Approval no: DEV2023/1379
Date: 20 March 2025

SITE AND DRAINAGE PLAN

Lot 523, Spindrift Road
CLINTON

JOB No. 22L523SP

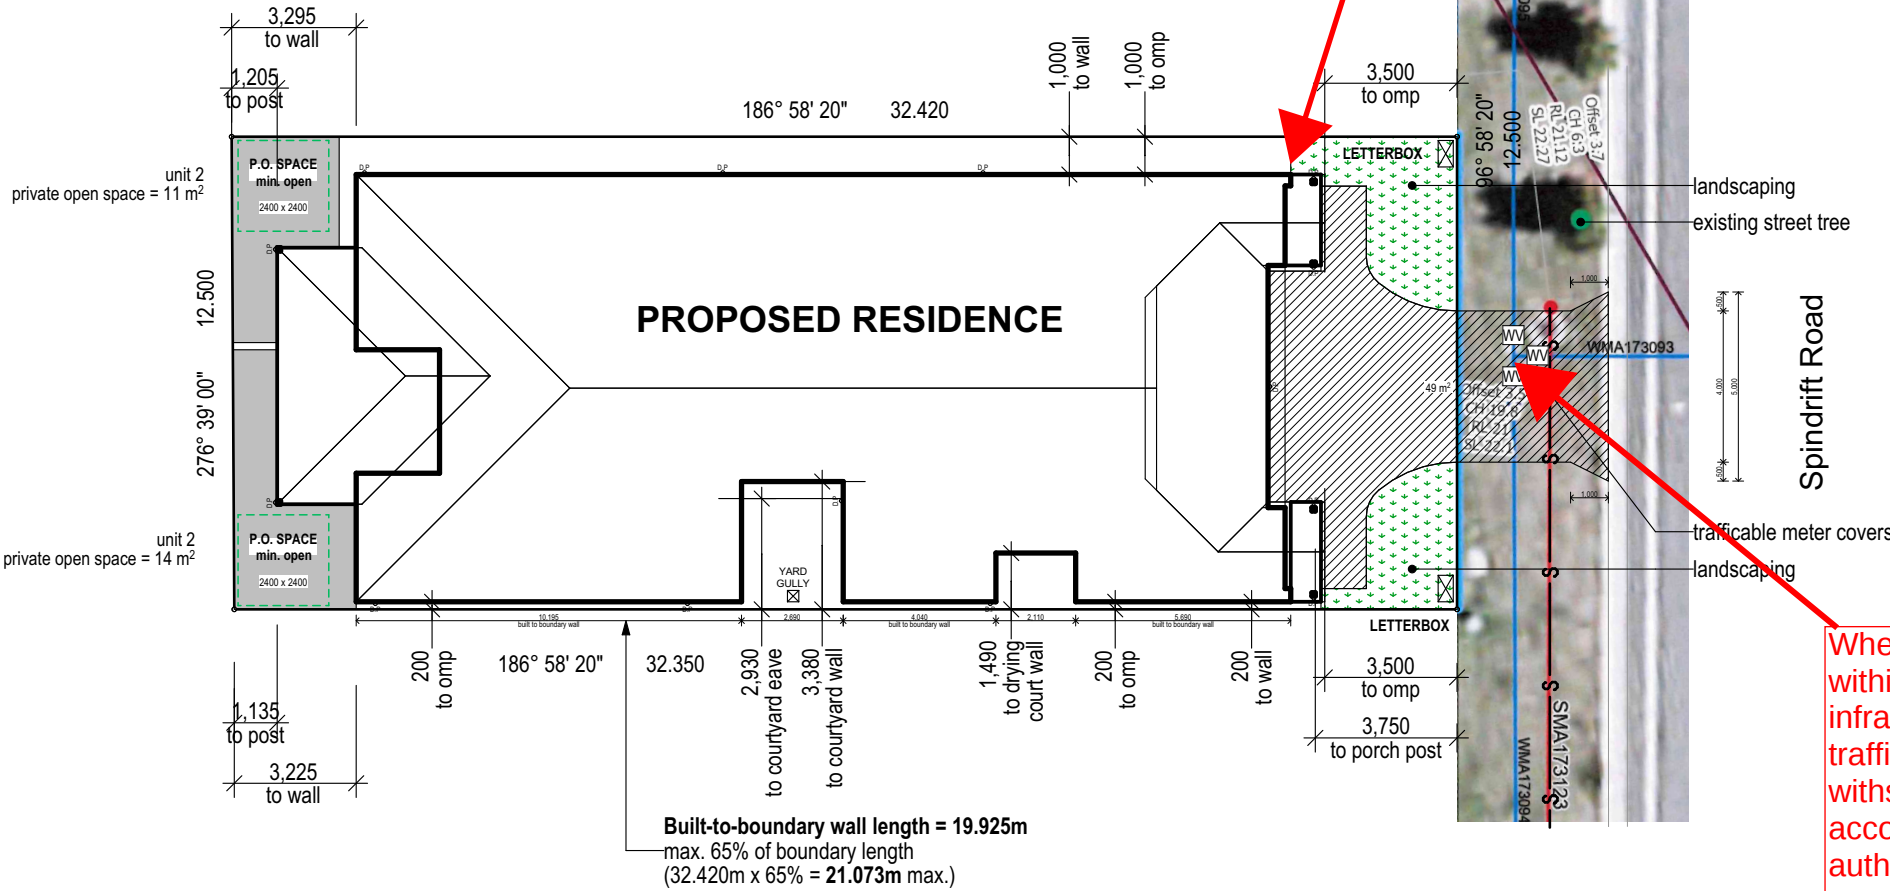
AMENDED IN RED

Where infrastructure remains within the driveway, all infrastructure must be trafficable and designed to withstand vehicle loads in accordance with the relevant authority standards
